SUBJECT: Benedictine Monastery Planned Area Development (PAD-37), Minor Amendment – Relocation of Monastery cooling tower and existing chiller.

RE: Minor Amendment to Benedictine Monastery PAD

THE BENEDICTINE
HISTORICAL RENOVATION
50% CONSTRUCTION DOCUMENT SET 11.13.20
800 N COUNTRY CLUB RD, TUCSON, AZ 85716
B-G102 CHILLER LOCATION
DIAGRAM

chiller area markup - pmm - 11.21.20
not for construction

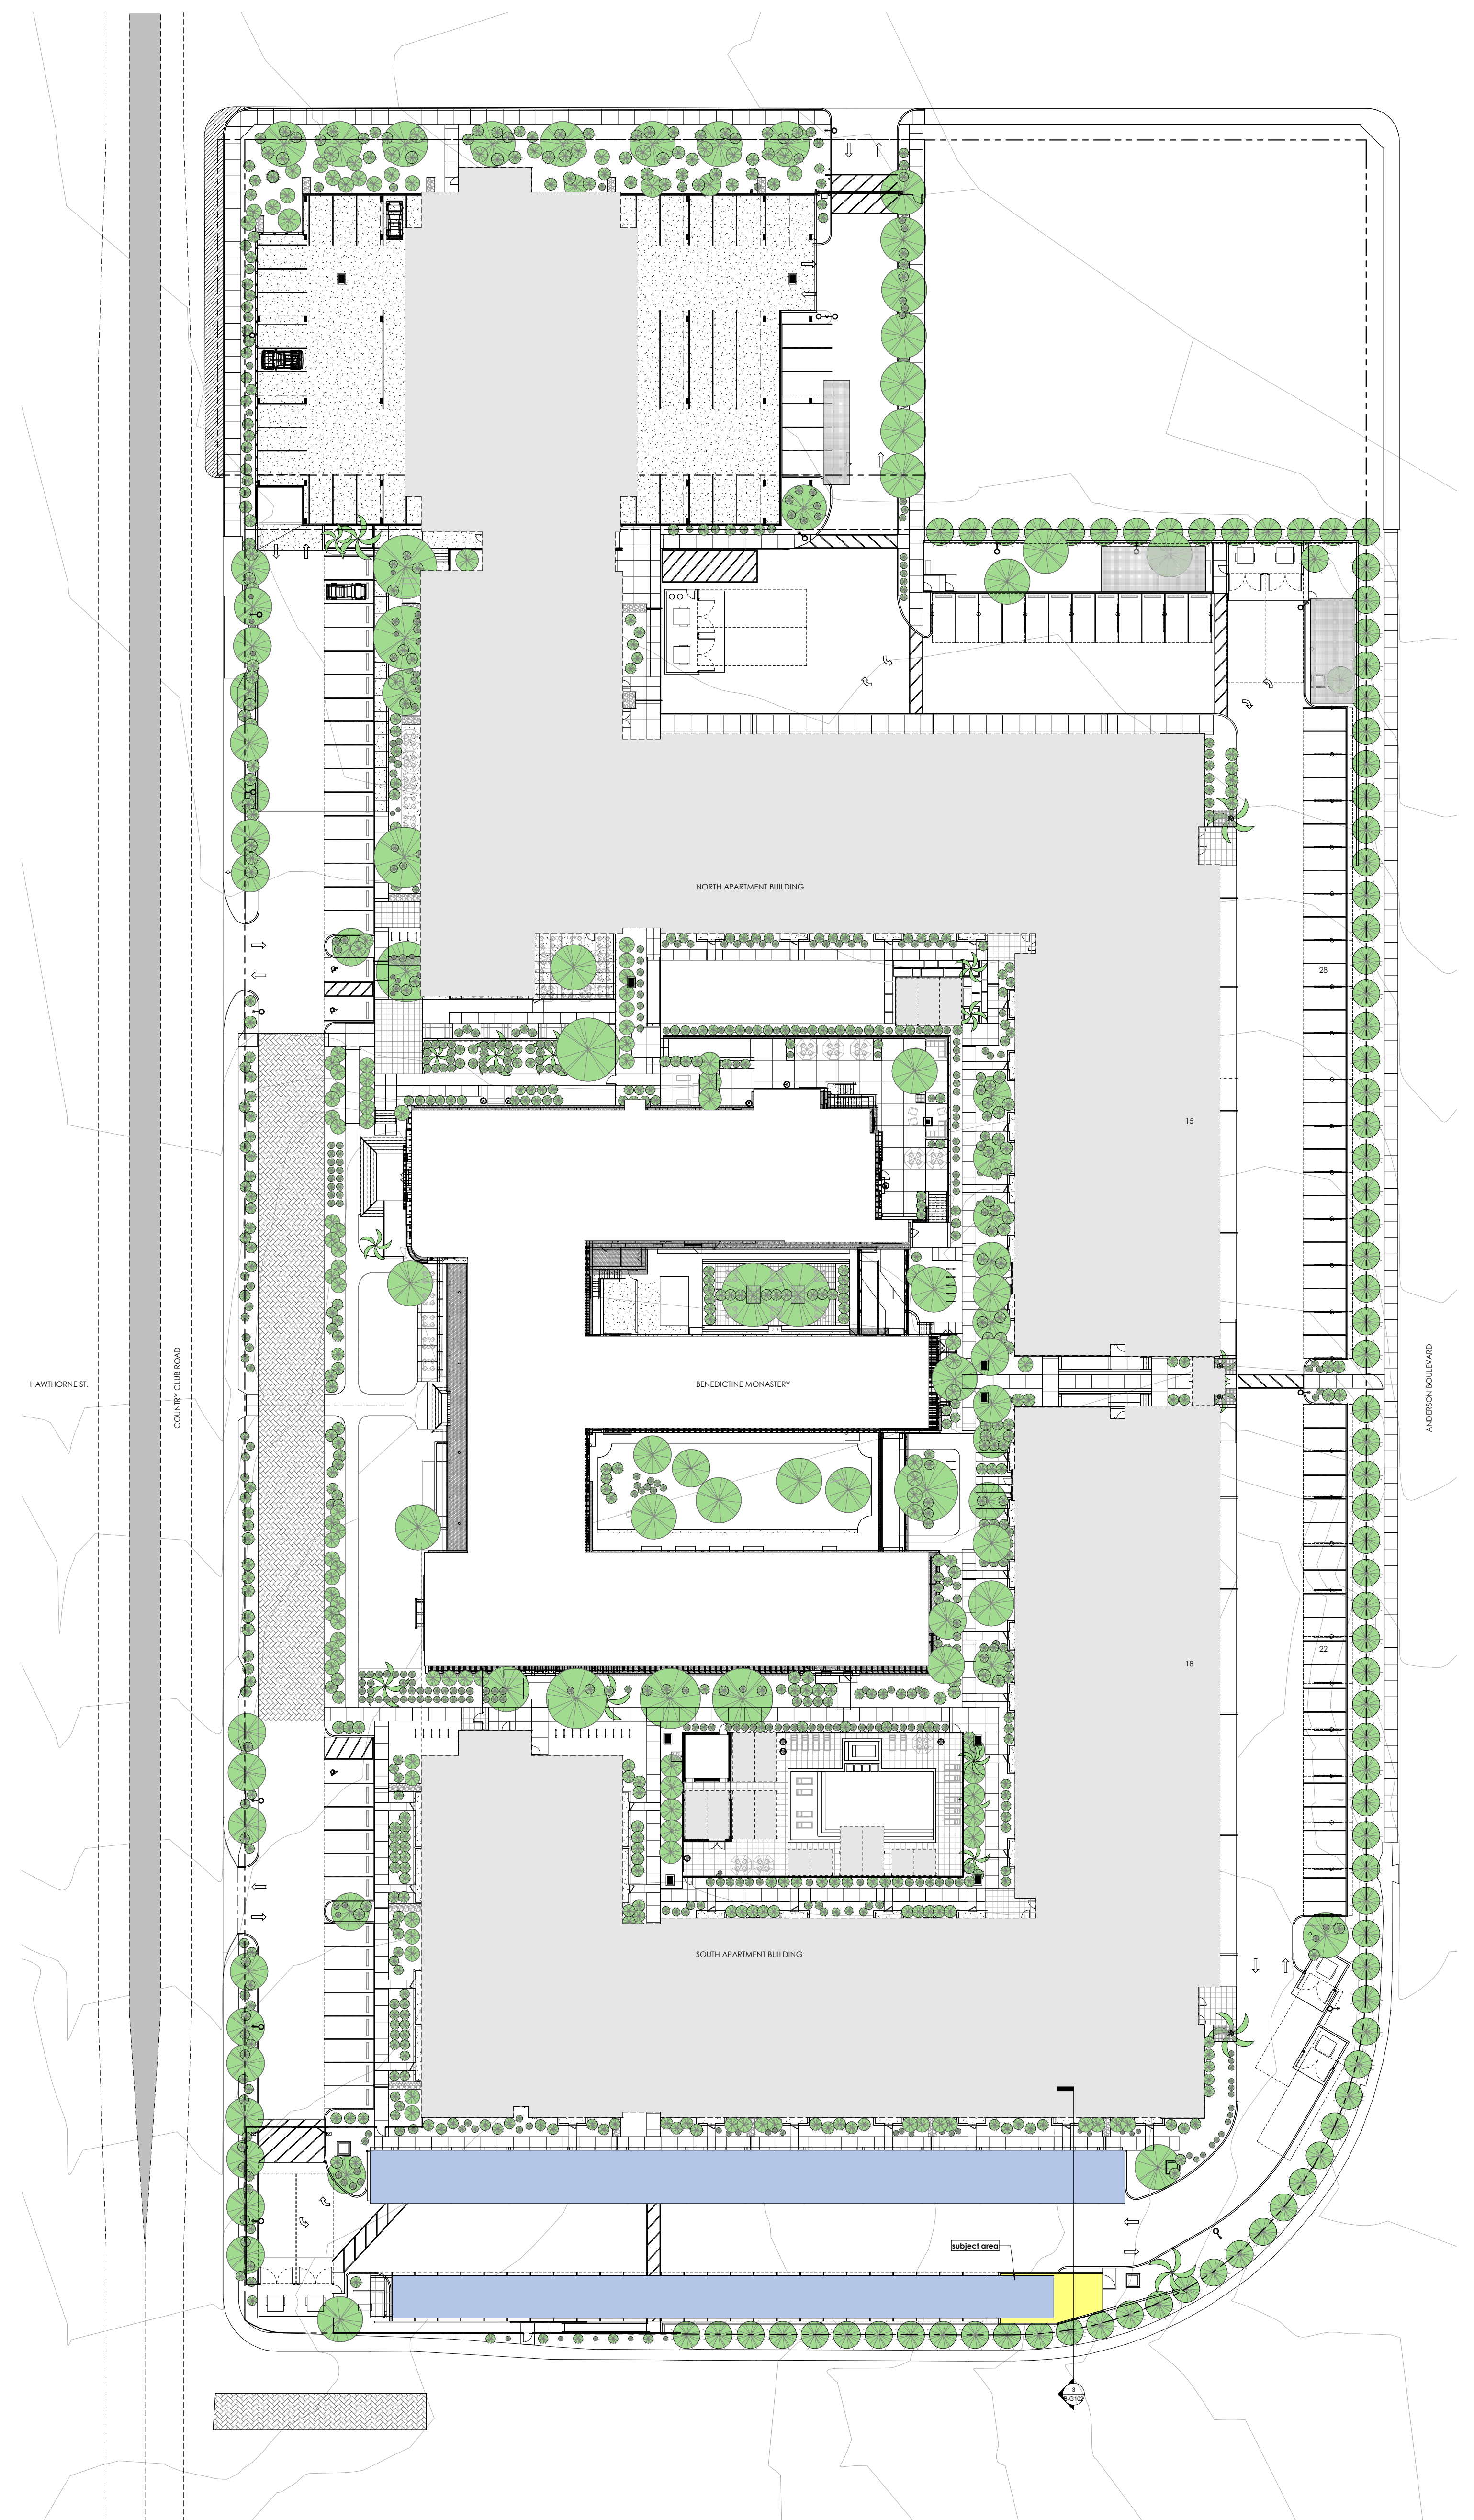
We are proposing to relocate this equipment to the southeast corner of the site at the curving intersection of 3rd Street and Anderson. It is proposed to be located and accessible from the parking area PAAL on its eastern side, behind 14' tall oleanders, and in a Concrete Masonry Unit (CMU) enclosure.
